**SUNDRY NOTICES AND REPORTS ON WELLS**  
**Do not use this form for proposals to drill or to re-enter an abandoned well. Use Form 3160-3 (APD) for such proposals.**

8. Well Name and No.  
Crowley Federal Com #1

9. API Well No.  
30-005-61805

**Crowley Federal Com 1  
30-005-61805  
Vanguard Operating, LLC  
October 16, 2018  
Conditions of Approval**

AFTER P+A

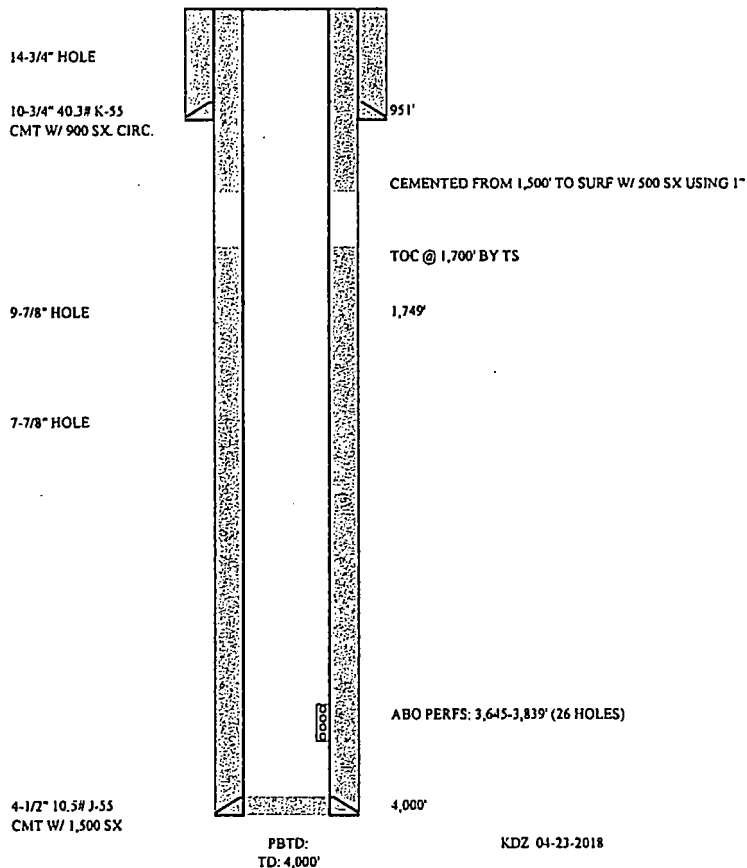
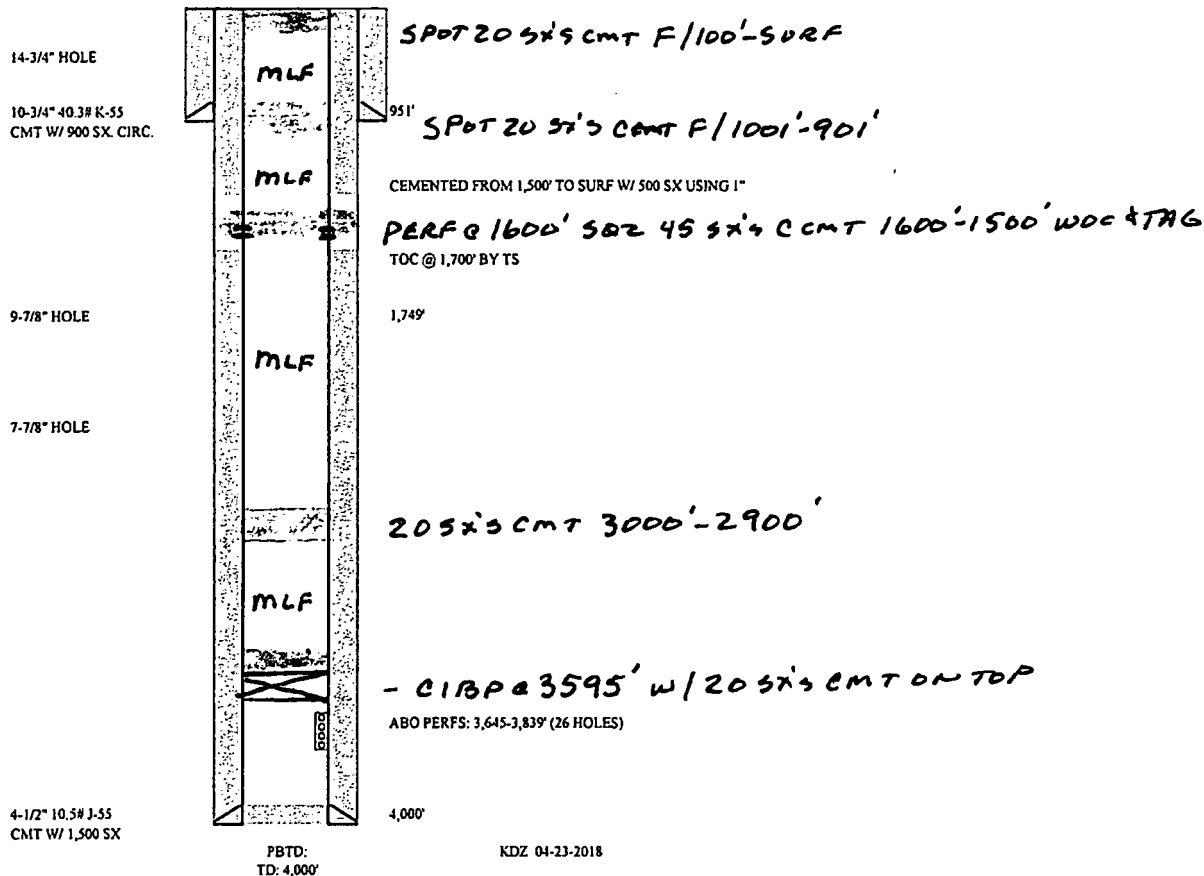
1. Notify BLM 24 hrs prior to MIRU to P&A.
2. Set CIBP @ 3595' RIH w/tbg & tag, circ mud laden fluid & test csg spot <sup>25</sup> 20 sx's "c" cmt 3595'-3495' WOC & tag if csg don't test.
3. Spot 20 sx's "c" cmt @ 3000'-2900' (Tubb) perf @ 1600' sqz 45 sx's "c" cmt WOC & tag @ 1600' or higher (Glorieta).
4. Spot 20 sx's "c" cmt F/1001'-901' (10 3/4" Shoe).
5. Spot 20 sx's "c" cmt F/100'-surf.
6. RD P&A equip, cut off wellhead, install dry hole marker, clean location & move off.

- 1. Operator shall place CIBP 3,595' (50'-100' above top most perf) and place 25 sx of Class C cement on top to seal the Abo Formation. WOC and TAG.**
- 2. Operator shall place a Class C cement plug from 3,000'-2,900' as proposed. WOC and TAG.**
- 3. Operator shall perf and squeeze at 1,600' as proposed. Operator shall place a Class C cement plug from 1,600'-1,450' to seal the Glorietta Formation. WOC and TAG.**
- 4. Operator shall place a Class C cement plug from 1,001'-901' as proposed to seal the 10-3/4" shoe. WOC and TAG.**
- 5. Operator shall perf and squeeze at 100'. Operator shall place a Class C cement plug from 100' to surface as proposed.**
- 6. See Attached for general plugging stipulations.**
